CITY OF MINNETONKA
PLANNING COMMISSION
MAY 16, 2019

Brief Description	Minor amendment to the existing Solbekken master development plan at 5743, 5742, and 5754 Shady Oak Road.
Recommendation	Adopt the resolution approving the amendment

Re: formerly the Music Barn Property, 5740 and 5750 Shady Oak Road
2.29 acres rezoned for the 15-unit Solbekken development
Now 5734, 5738, 5742, 5746, 5750 and 5754 Shady Oak Road
Request for PUD amendment and plat approval related to revised Garage
Dimensions for the three 4-plex condominium buildings

1 FIRST LEVEL FLOOR PLAN - 5734 SHADY OAK ROAD
A1.1 1/4" = 1'-0"

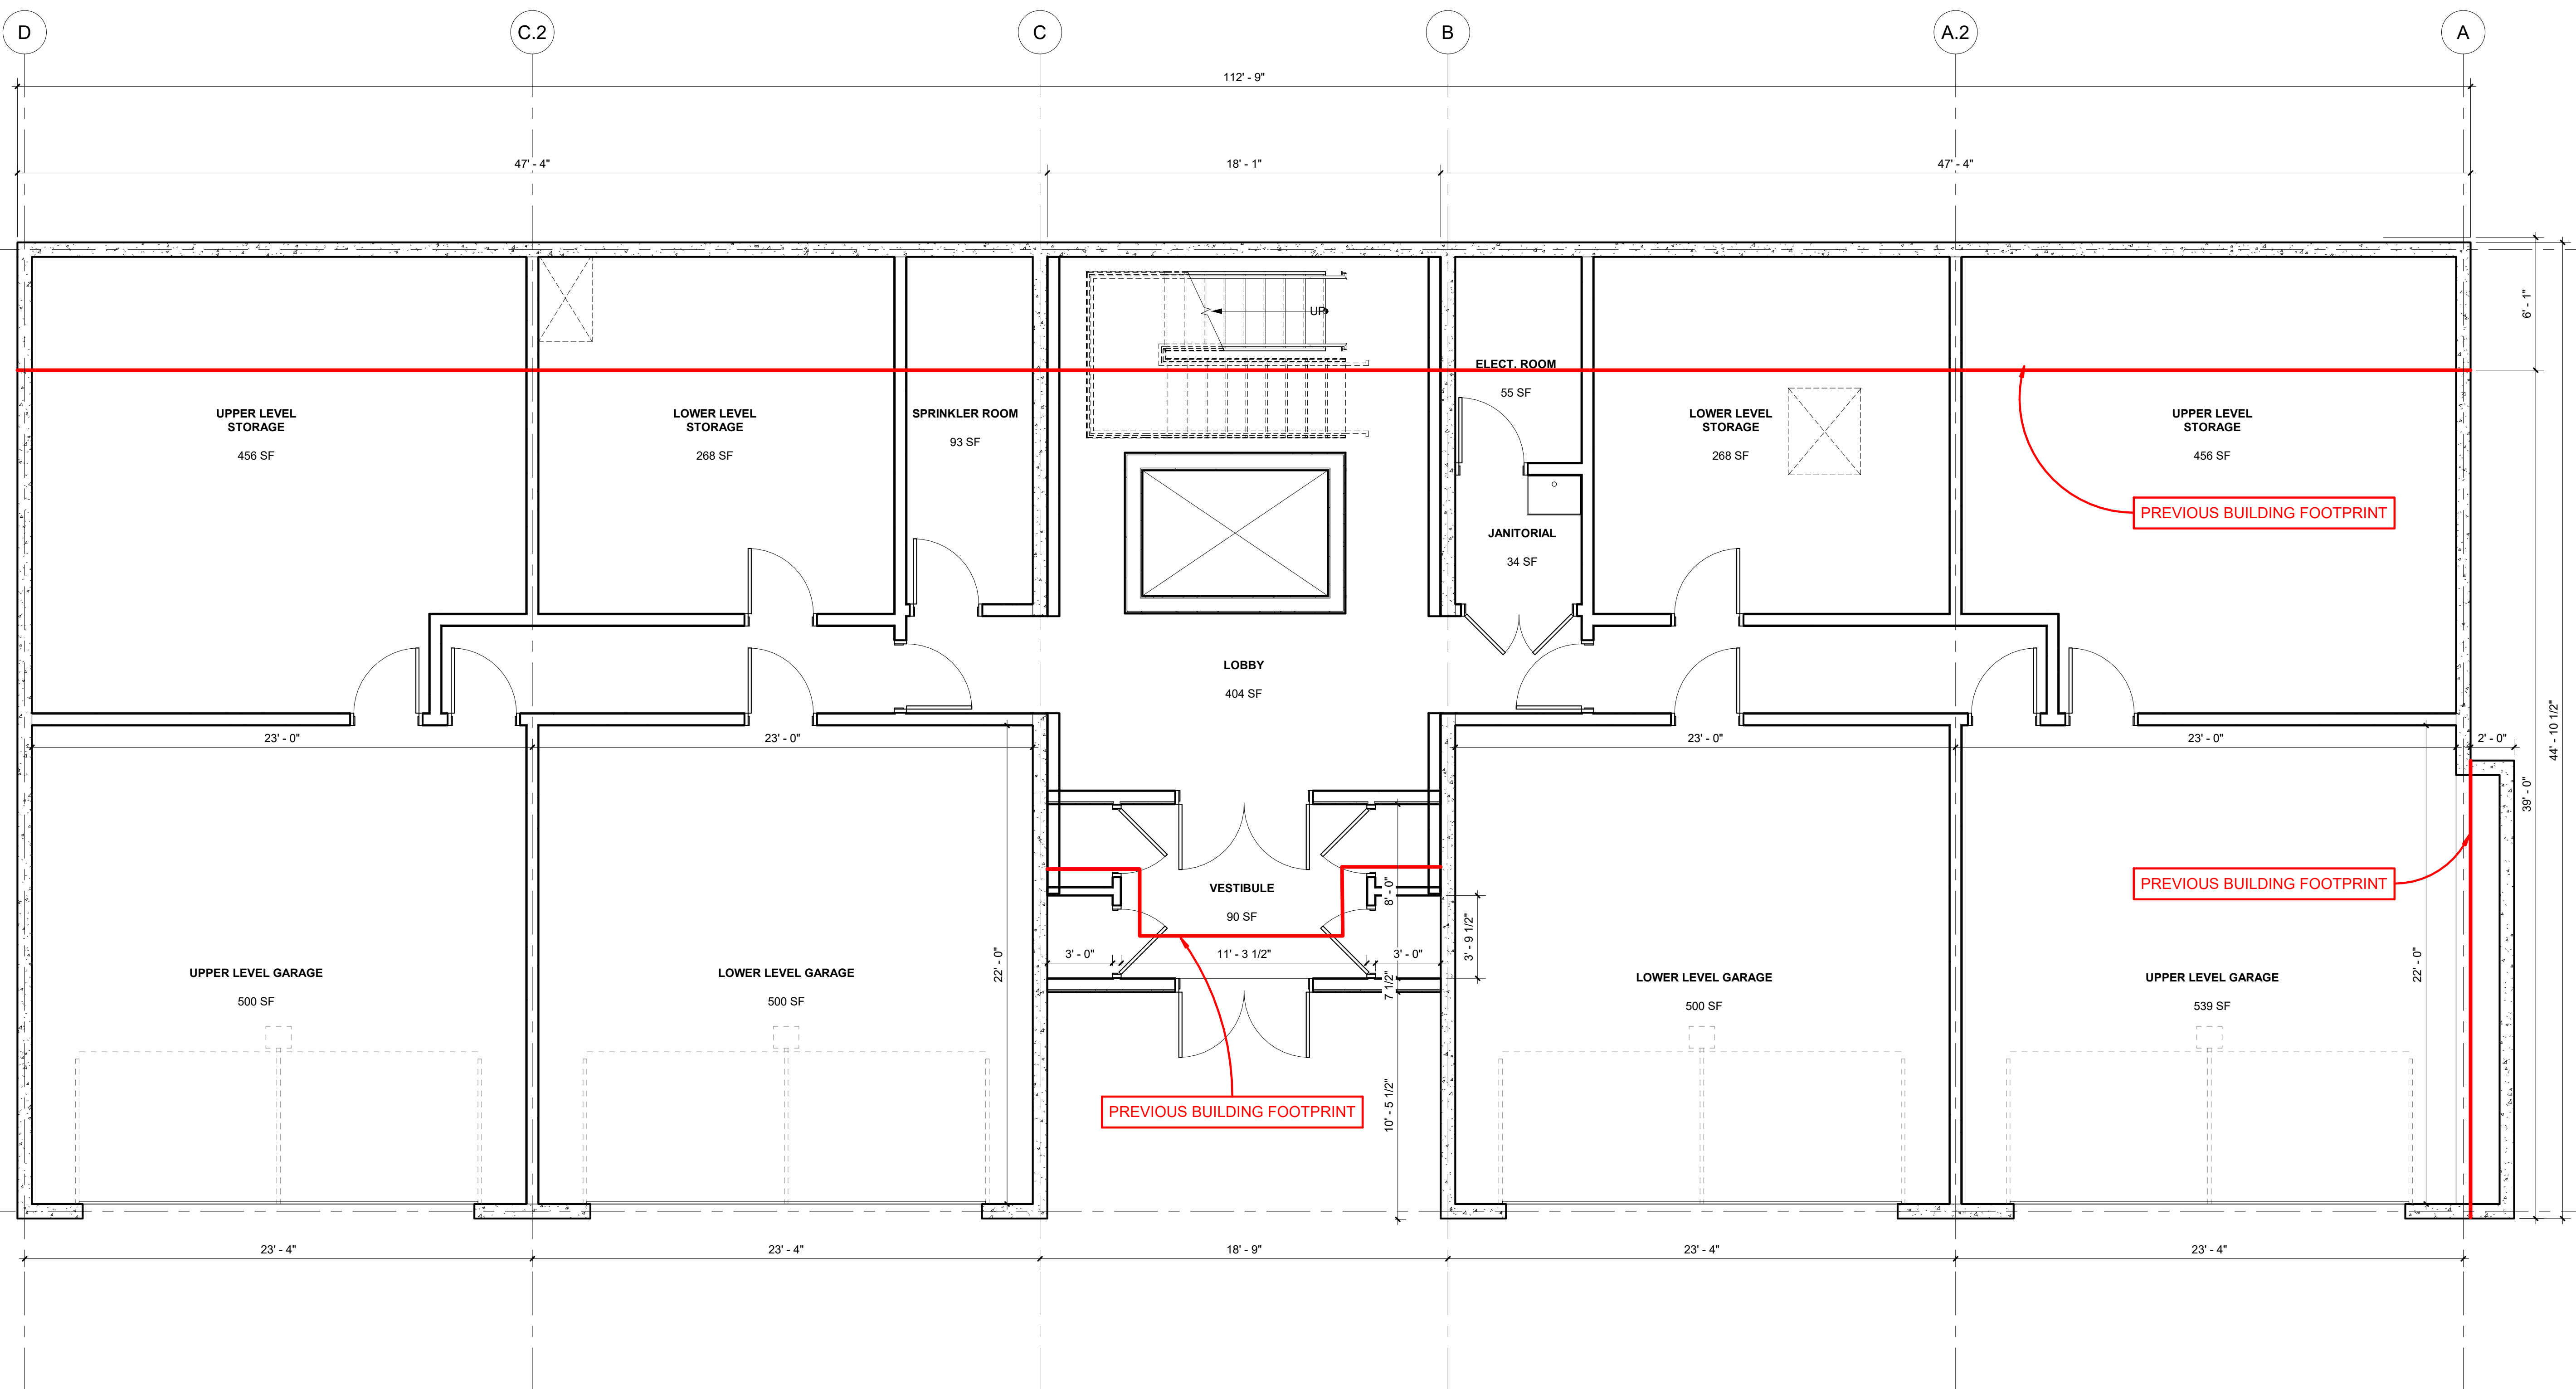
- Building Footprint Change Exhibit—which illustrates the current garage footprint and shows **in red color** the previous location of the west garage wall.
- Garage Plan Exhibit—First Level Floor Plan which shows the layout of the garage level now and indicates **in red color** where the west (rear) wall was located previously. There is a minor change standard for the lobby entrances to provide more space in the vestibule to allow for package delivery lockers. You will also notice a very small overhang added for a deck on the north elevation of this building (5734). The southern elevation of building 5754 has the same small overhang.
- Architectural Site Plan Amendment—While there is more detail in the civil drawings, this site plan replaces the original architectural site plan (Sheet A-1.1 in our original submission). The **red line shows** the previous boundary of the garage walls.

5746 & 5750 EXCAVATION EXHIBIT

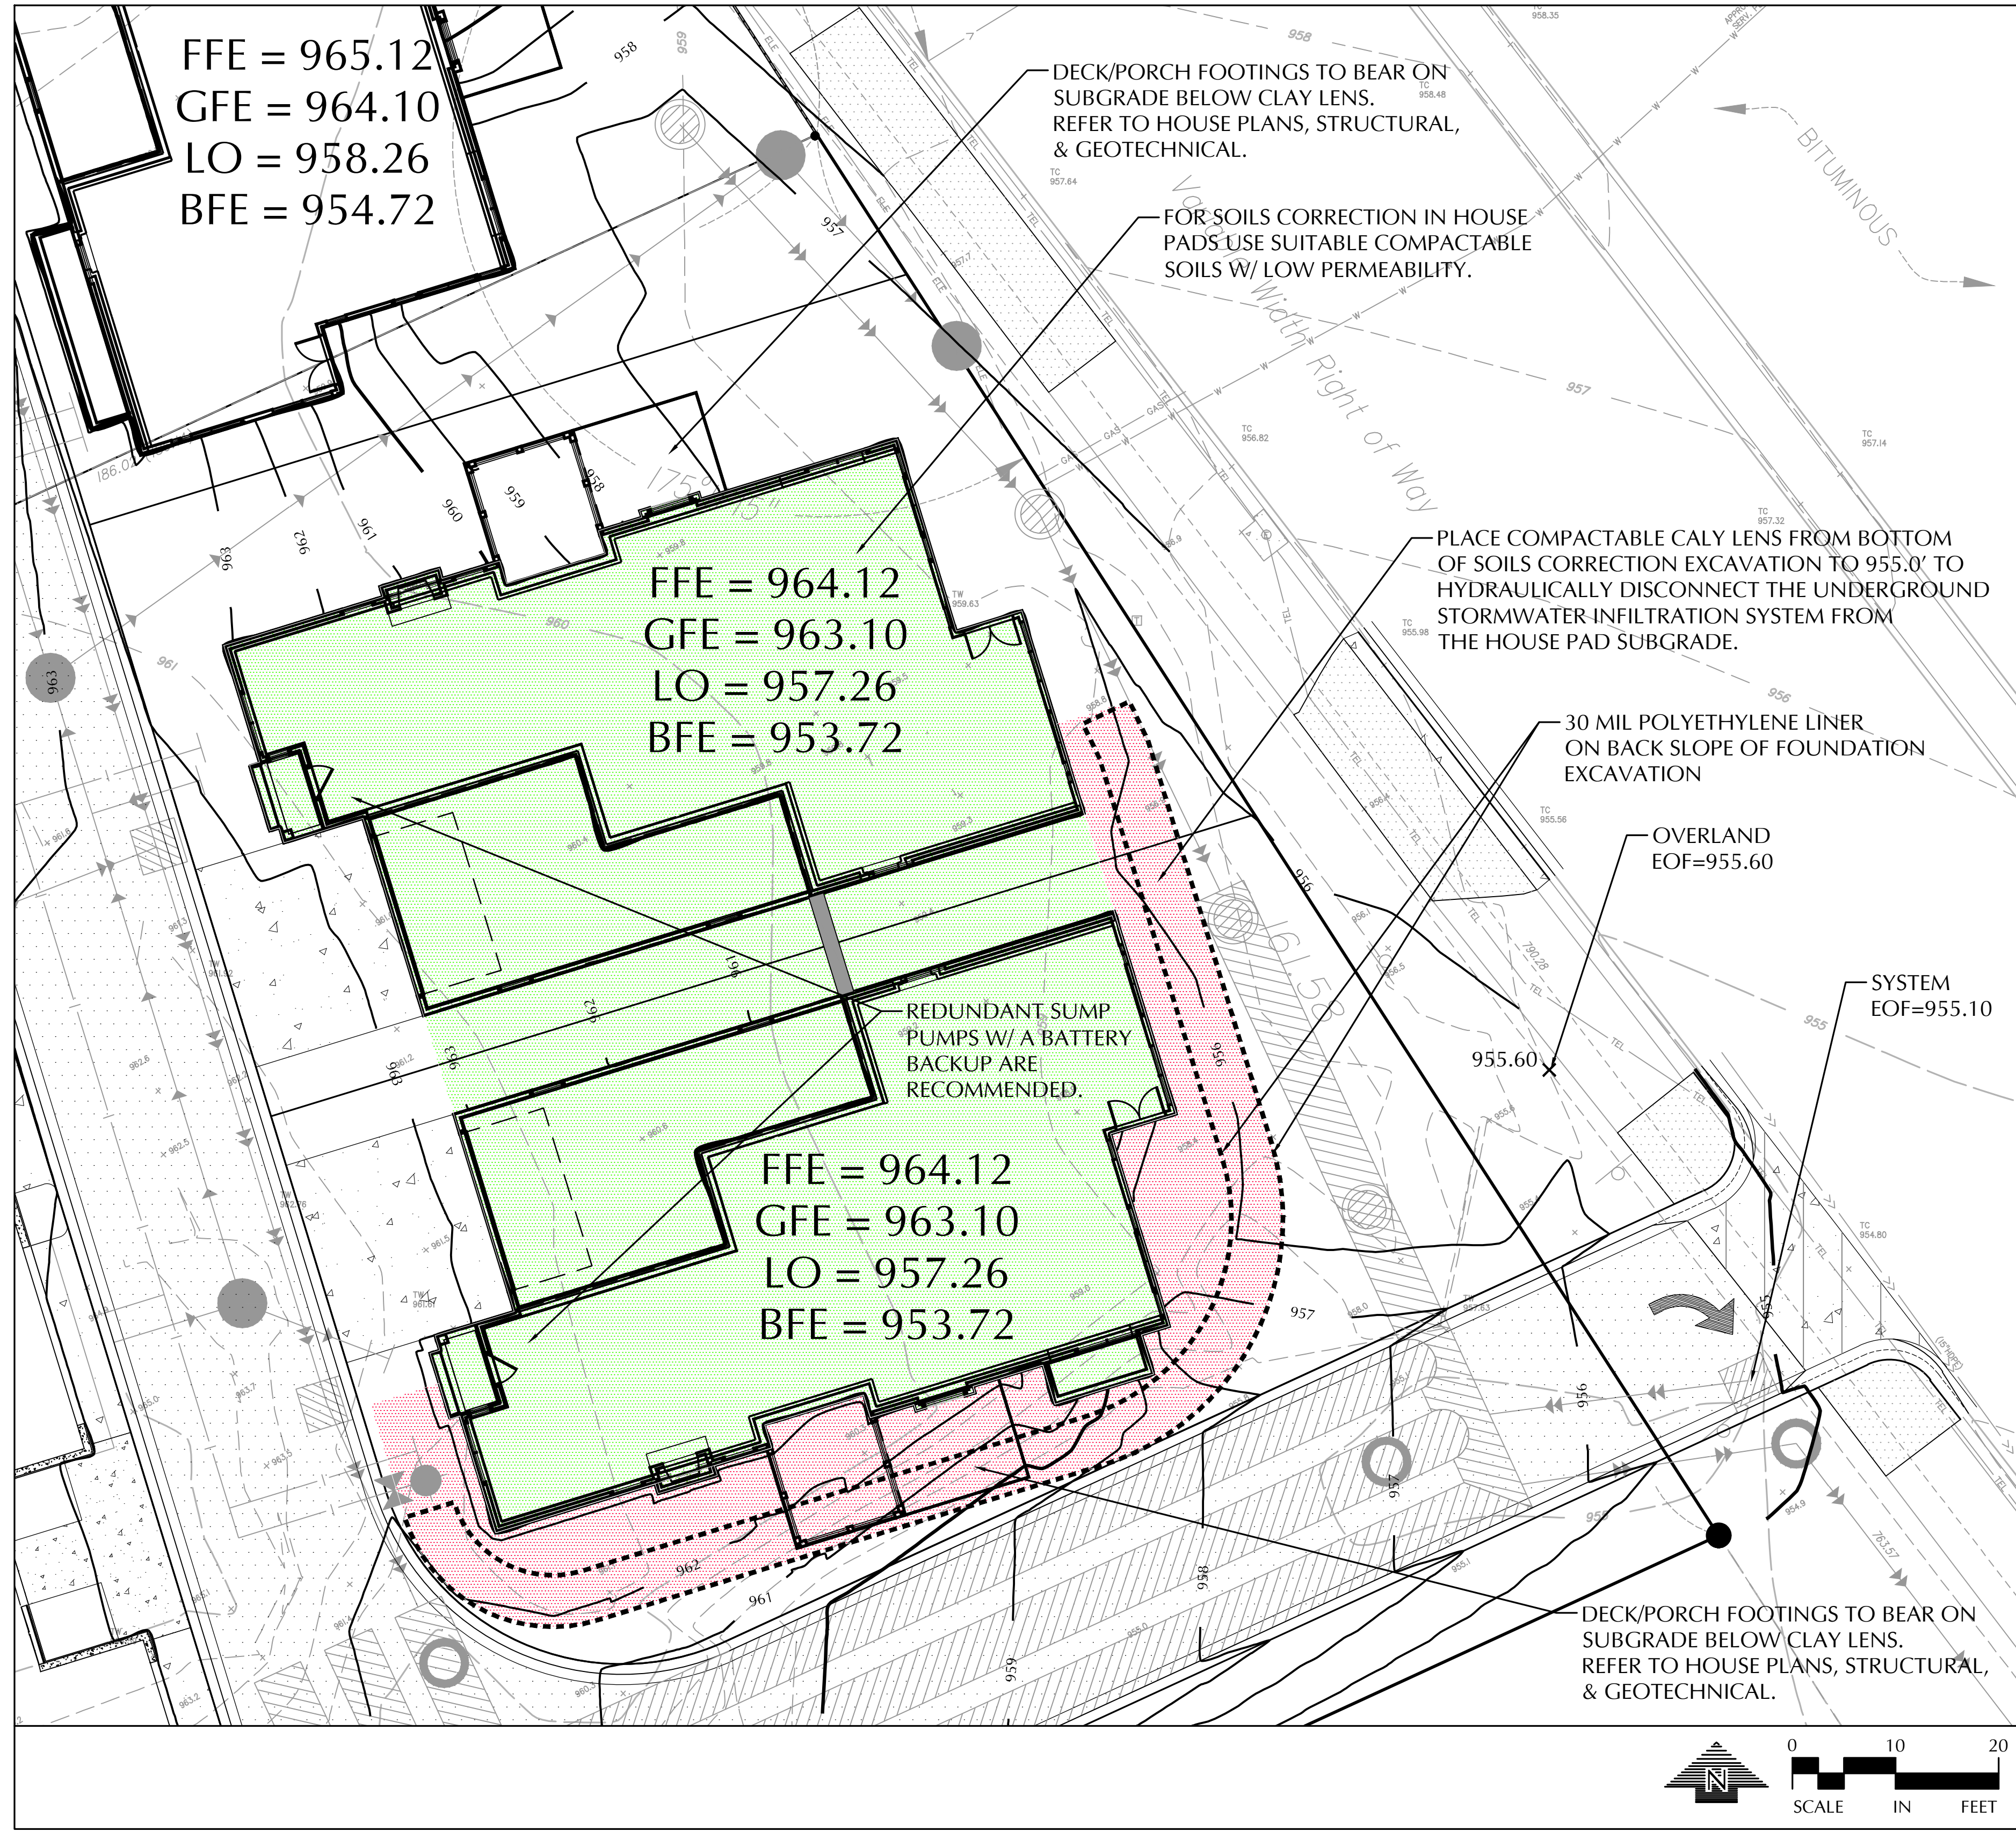
Finding: As proposed, the building foundations would be shifted toward a retaining wall currently under construction. The change would not impact the internal sense of order, amount/location of open space, compatibility with adjacent/neighboring structures, or circulation.
